Technical Service Bulletin: TSB200032

Additional Pre-Lubrication Switch

Product Affected

- QSK50 CM850
- QSK50 CM2150

Figure 1, Fuel Pump Drive

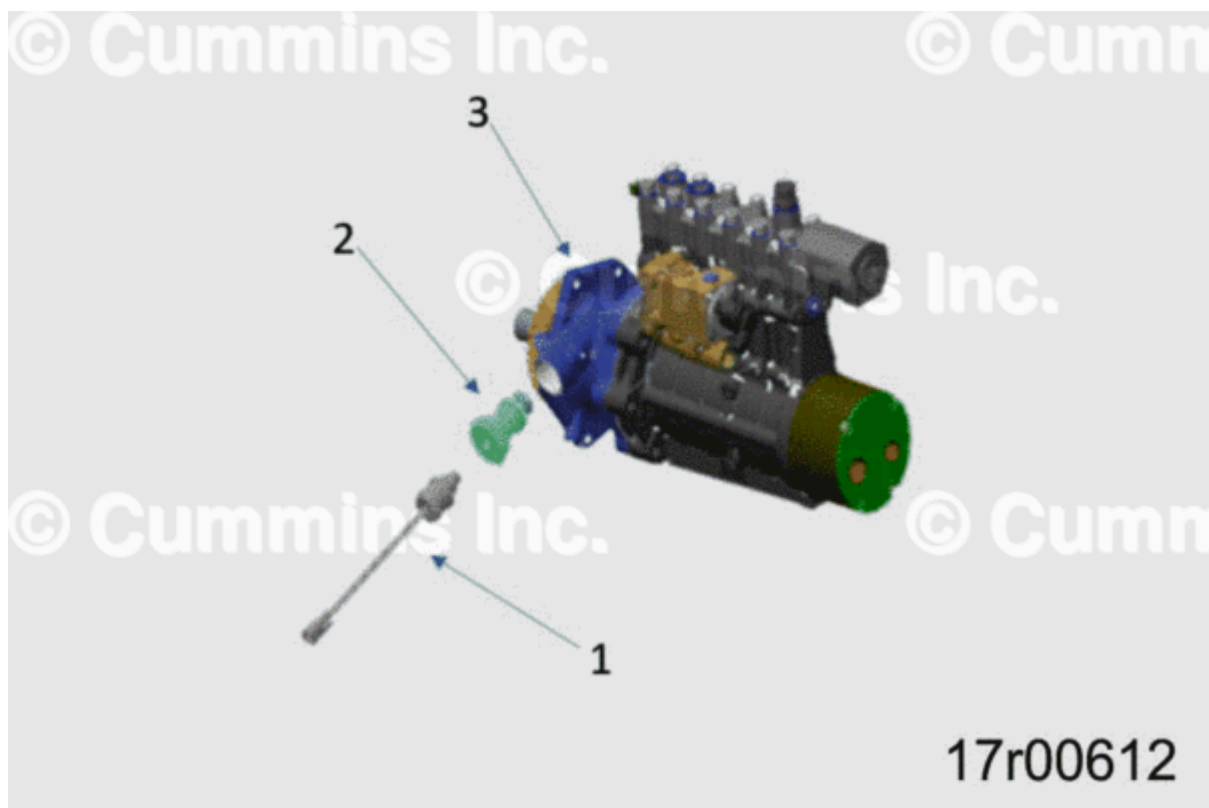
Engines had an additional pre-lubrication pressure switch intalled in fuel pump drive. The first engine serial number (ESN) to have these parts installed from Daventry plant is ESN 33216387. A service parts kit, Part Number 5579009, is available for service up-fit to help ensure proper fuel pump lubrication prior to start.

The second oil pressure pre-lubrication switch confirms that there is a minimum of 4 psi at the fuel pump drive prior to the engine cranking.

1. Refer to Procedure 009-011 in Section 9 (</qs3/pubsys2/xml/en/procedures/28/28-009-011.html>) to install the new fuel pump accessory drive support, Part Number 5376094. See Figure 1.
2. Connect the new pressure switch wire harness extension to the main engine harness. See Figure 2.
3. Connect existing oil pressure switch plug. See Figure 3.
4. Route wire harness behind breather box (Figure 4) and behind fuel block (Figure 5).
5. Use provided capscrews to loosely secure harness as shown. See Figure 6.
6. Install oil pressure switch into drive and connect to wire harness. See Figure 7.
7. Torque harness mounting capscrews to block (45 Nm [33 ft-lb]). Use provided wire tie clamps to secure wire harness to adjacent components. See Figure 6.
